Part Name: Replacement Skidtube, High Gear with Standard Wearplates Fits LH or RH

DRAWING NO. D2650	TITLE 206/407 SKIDTUBE ASSEMBLIES	REV. F	DART AEROSPACE LTD ENGINEERING ORDER		D.E.O. NO. D2650-F-1	SHEET NO. SHEET 1 OF 1	SCALE NTS
DRAWN <i>[Signature]</i>	CHECKED A.P.	MFG. APPR. <i>[Signature]</i>	APPROVED <i>[Signature]</i>		DE APPR. <i>[Signature]</i>		
DATE 12.10.12	DATE 12.10.22	DATE 12.10.22	DATE 12.10.22		DATE 12.10.22

PURPOSE:

CHANGE C'BORED WELDED CROSSBOLT SPACERS TO SWAGED SPACERS

DETAIL B

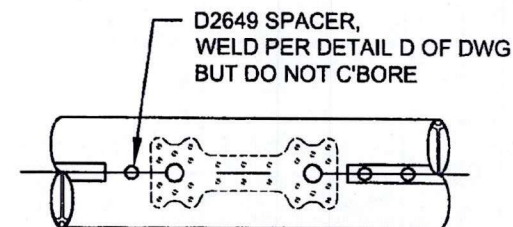
C'BORED HOLES ARE **NOW SWAGED** PER DETAIL G BELOW. FOR THE Ø0.375 HOLE THAT IS NOT C'BORED, WELD PER DETAIL D OF DWG (SEE AMENDED DETAIL B FOR REFERENCE).

AMENDMENT TO DETAIL B
NOT TO SCALE

DETAIL G

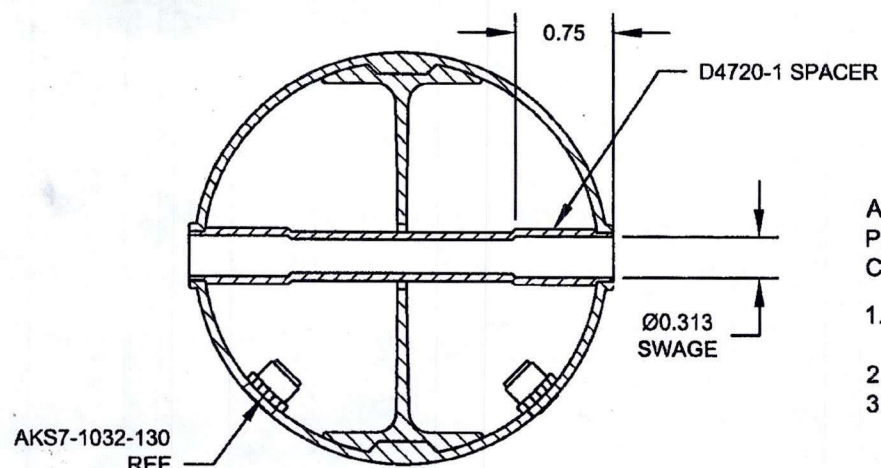
FOR Ø0.375 HOLES ONLY
FOR HOLES THAT ARE CURRENTLY C'BORED ONLY
NOT TO SCALE

AFTER DRILLING AND BENDING ASSEMBLY
PERFORM THE FOLLOWING FOR Ø0.375 HOLES THAT ARE
CURRENTLY C'BORED:

1. INSERT D4720-1 SPACER, 16 PL (-1) OR 17 PL (-3)
OR 19 PL (-5) OR 23 PL (-7)
2. SWAGE TO Ø0.313 X 0.75 DP PER QSI 002
3. TRIM / GRIND FLUSH PER QSI 002
